Access Compliance Report

Public Rights-of-Way

(Curb Ramps)

Intersection ID: 10036062	Main Street: RIVERGATE_PY	Cross Street: N/A	Location:	N
ADA ID: EF5BBE34CCF7	Ramp Type: Perp	Initial Pass/Fail: Fail	Overall Compliance: No	Severity Score: 10
Codes/Mitigation Info/Possible Solution		Field Measurements/Component Compliance

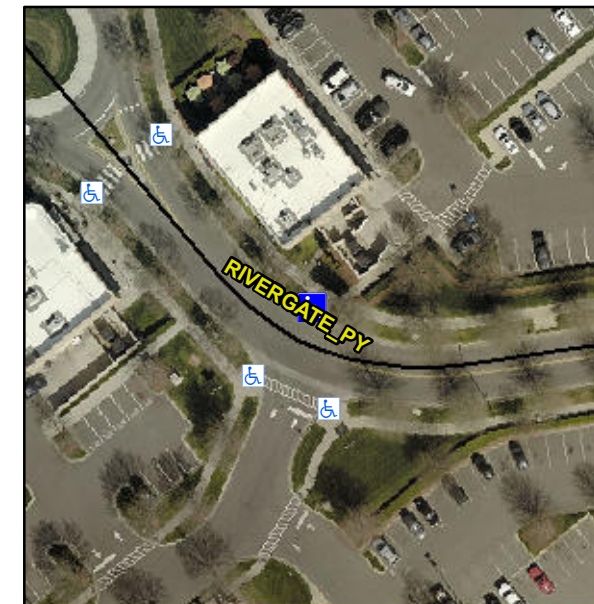
Not Found, R304.5.1, R304.5.3

Compliance	Description	Data	Compliance	Description	Data
N/A	Ramp Length (in)	95.0	Yes	Ramp Slope (%)	6.7
No	Ramp Width (in)	42.0	No	Ramp XSlope (%)	2.2
N/A	Flare Type LT	N/A	N/A	Flare Type RT	N/A
N/A	Flare Slope LT (%)	N/A	N/A	Flare Slope RT (%)	N/A
N/A	Flare Traversable LT?	N/A	N/A	Flare Traversable RT?	N/A
N/A	Landing Length (in)	N/A	N/A	DWS Provided?	N/A
N/A	Landing Width (in)	N/A	N/A	DWS Contrast?	N/A
N/A	Landing Slope (%)	N/A	N/A	DWS Length (in)	N/A
N/A	Landing X Slope (%)	N/A	N/A	DWS Full Width?	N/A
N/A	Landing Curb? (Y/N)	N/A	N/A	DWS Offset (in)	N/A
N/A	Shared Landing?	N/A			
N/A	Gutter Ponding?	N/A	N/A	Gutter Slope (%)	N/A
N/A	Gutter Lip Ht (in)	N/A	N/A	Gutter X Slope (%)	N/A
N/A	Painted X Walk1?	No	N/A	Painted X Walk2?	N/A
	X Walk 1 Direction	To SW		X Walk 2 Direction	N/A
N/A	X Walk 1 Width (in)	N/A	N/A	X Walk 2 Width (in)	N/A
	X Walk 1 Slope (%)	3.8		X Walk 2 Slope (%)	N/A
	X Walk 1 X Slope (%)	0.9		X Walk 2 X Slope (%)	N/A

N/A	Ramp inside XWalk1?	N/A	N/A	Ramp inside XWalk2?	N/A
	Road Slope (%)	N/A	N/A	Clear Space?	N/A
	Road X Slope (%)	N/A	N/A	Clear Space to XWalk (in)	N/A
N/A	Any Obstructions?	N/A	N/A	Storm Grate/Utility Hazard?	N/A
	Obstruction Type			Storm Grate/Utility Type	
		N/A			N/A
			Yes	Surface Condition? (G/P)	Good

Remove & Replace Entire Ramp.

\$ 1850.00
